PRODUCT ADVISORY

FPO75 Voltage Selection Jumper

September 2024 Technical Bulletin TB0006

ALERT: FPO75 Voltage Selection Jumper Change

FP075 Voltage Selection Jumper has moved to match other FP0 models

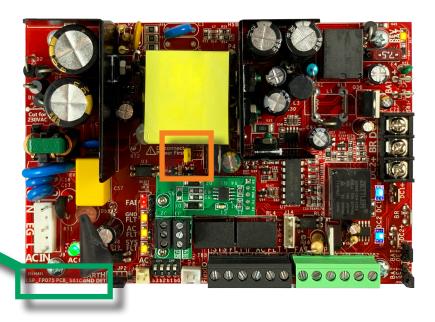
To provide better consistency between models, the yellow voltage selection jumper on the FP075 has been moved from the center of the board to the top right corner. This provides easier access and better matches the output voltage selection location of the FP0150 and FP0250.

This change is present at board revision S06 and above. See below for location of the PCB revision.
